STATE OF NORTH CAROLINA  
DEPARTMENT OF TRANSPORTATION

Subject: **Response to US Army Corps of Engineers Letter** for the proposed NC 133 Connector from NC 211-133 (Southport Supply Road) to NC 87-133 (River Road), Brunswick County, TIP R-3324.

References: Application for an Individual Section 401 Water Quality Certification dated July 19, 2012  
USACE Request for Additional Information Letter dated, September 18, 2012 (received September 24, 2012).  
NCDOT Response to US Army Corps of Engineers Letter dated, October 18, 2012.

PLAN VIEW  
SITE IX

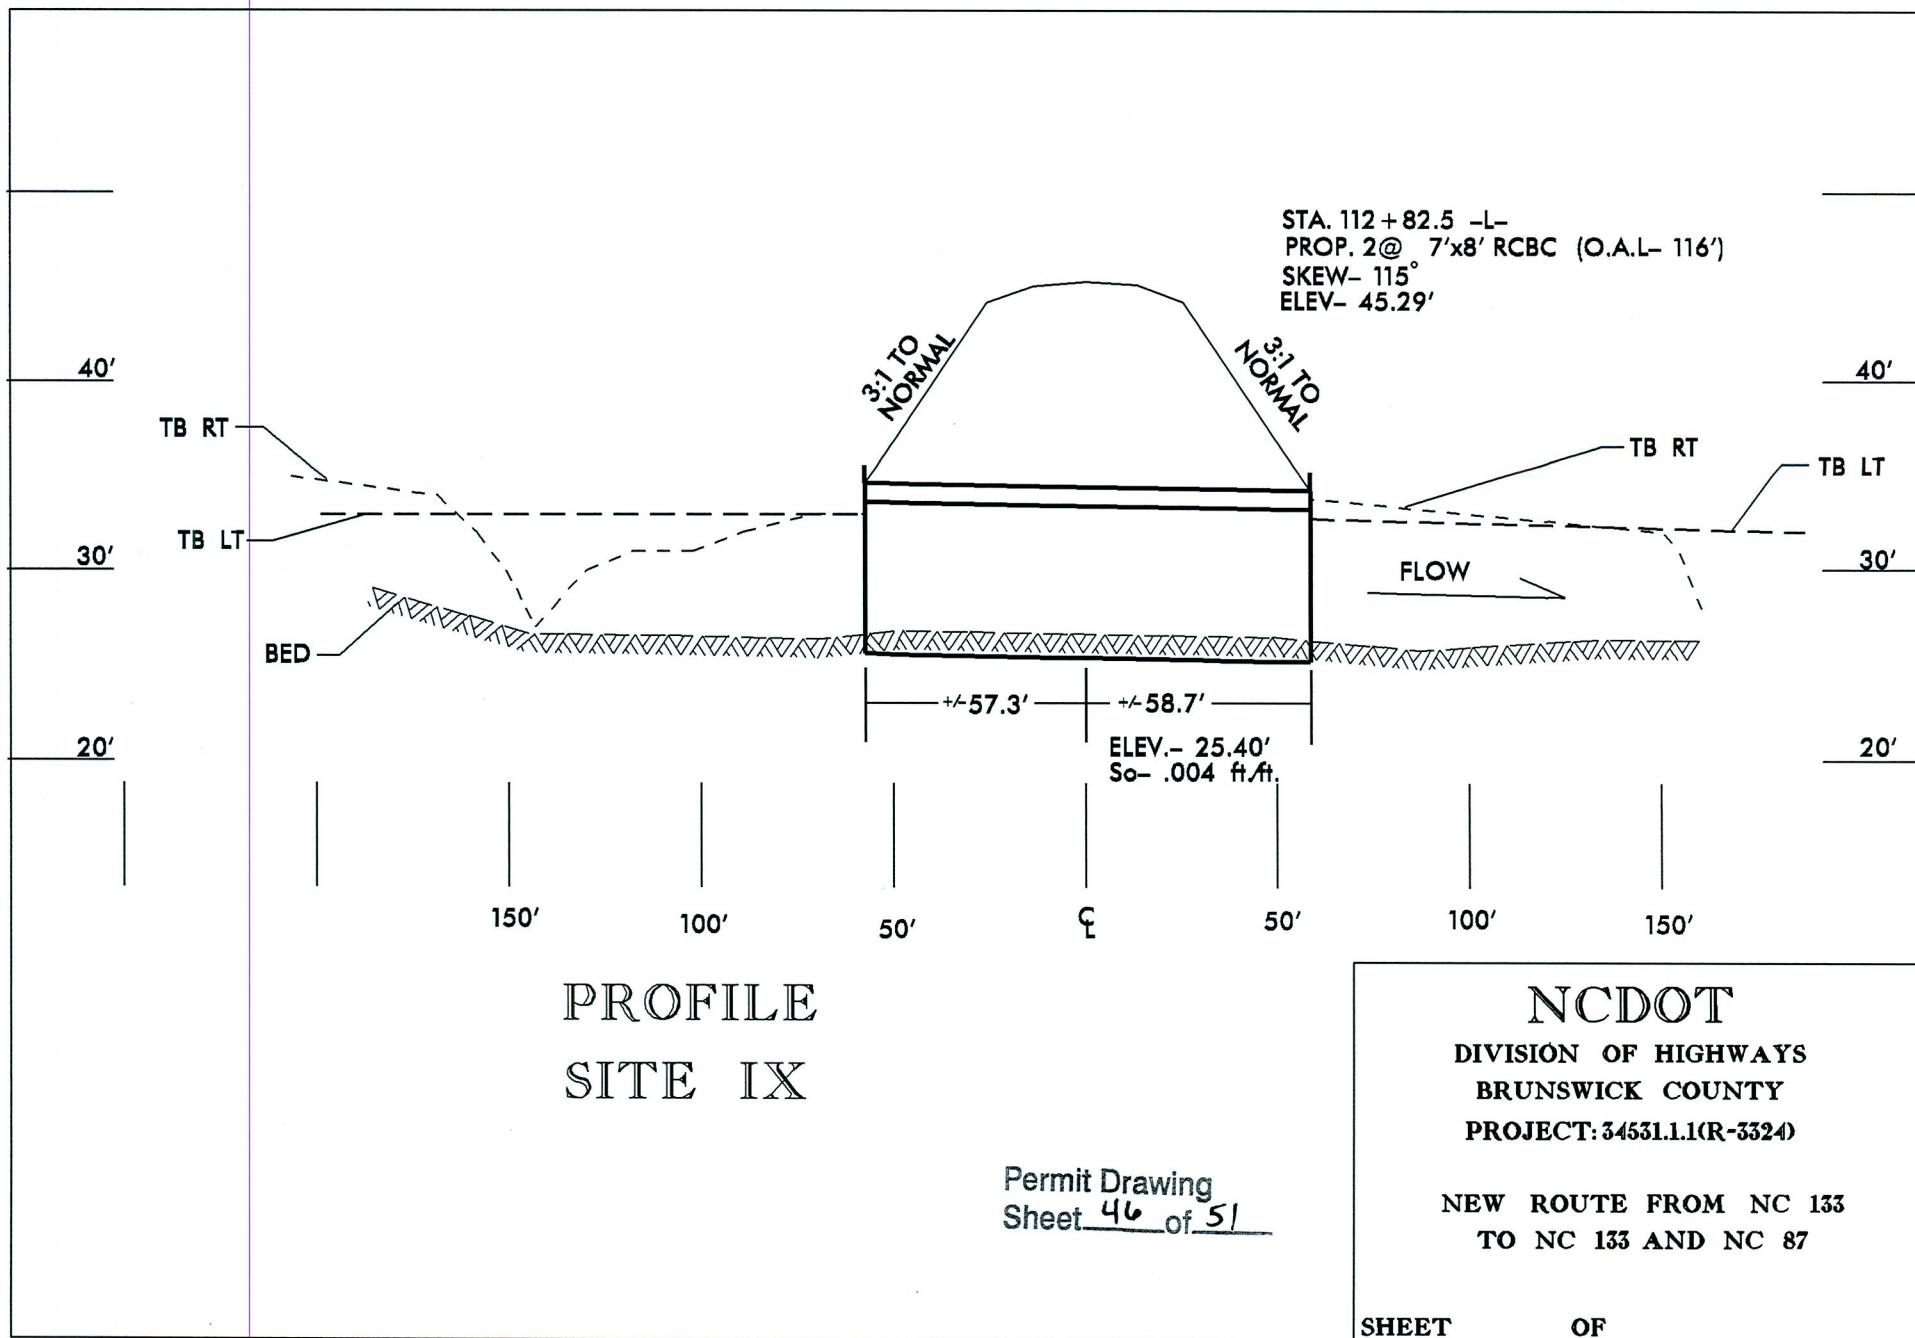
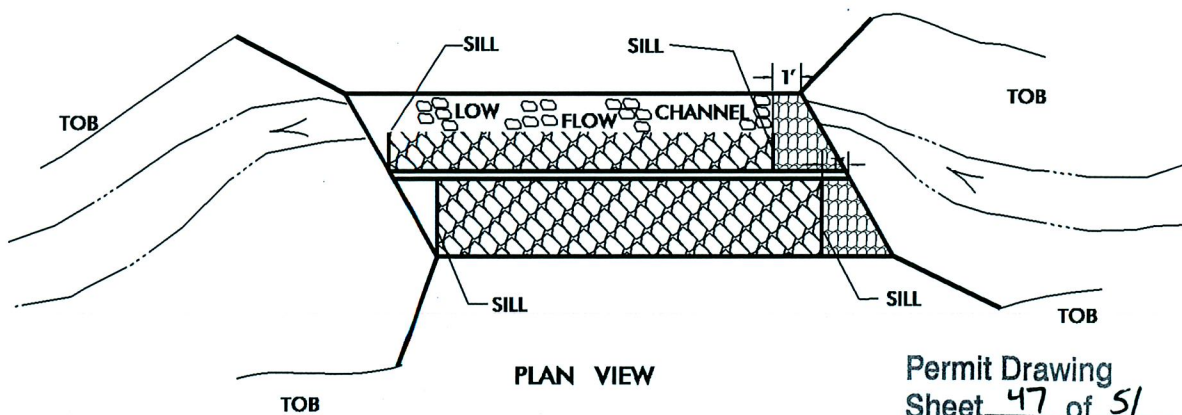
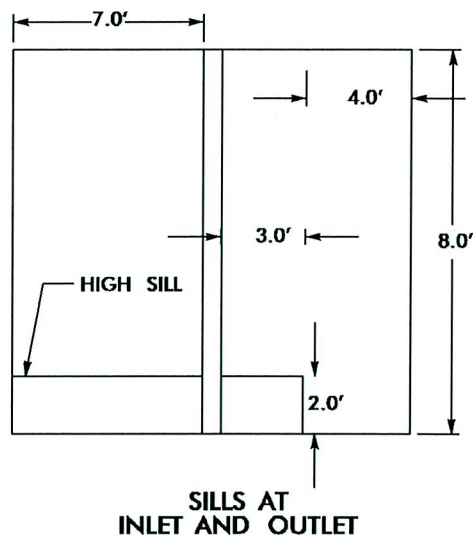
8. Site 9: *Are there cross sections of the sill to maintain low flow conditions in the current submittal?*

A detail showing the sill layout for the culvert has been added to the permit drawings. The low flow conditions are being maintained.

**SITE XI**  
**-L- STA. 127 + 46**  
**1 @ 9' X 7' RCBC**

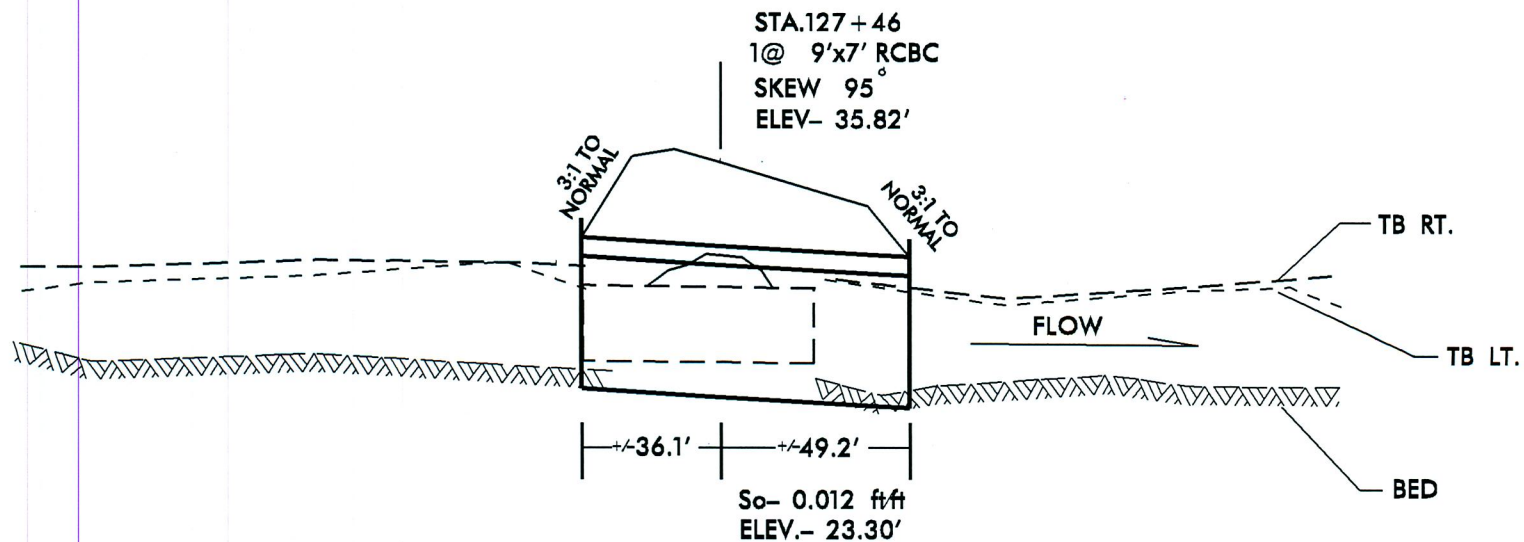
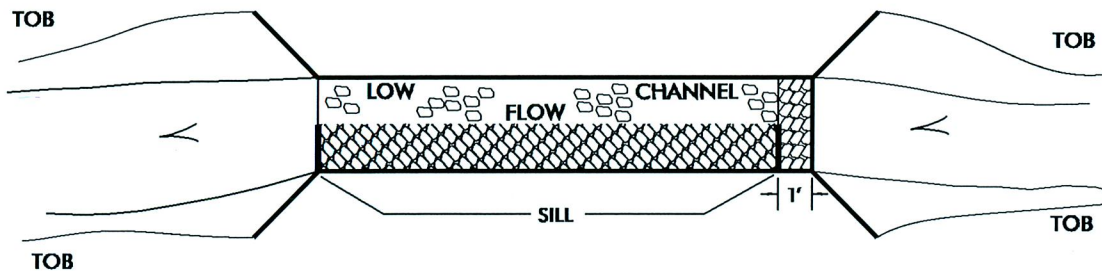
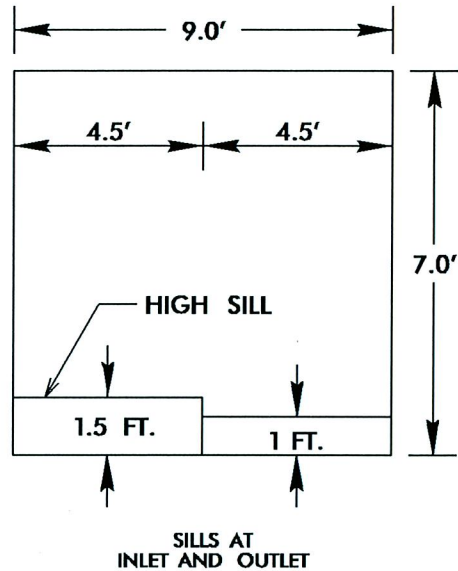
9. Site 11: *Existing channel is approximately as wide as current 48" structure, yet new structure proposed is 9'. What is being implemented to maintain the low flow channel at this proposed crossing?*

A detail showing the sill layout for the culvert has been added to the permit drawings. The low flow conditions are being maintained.
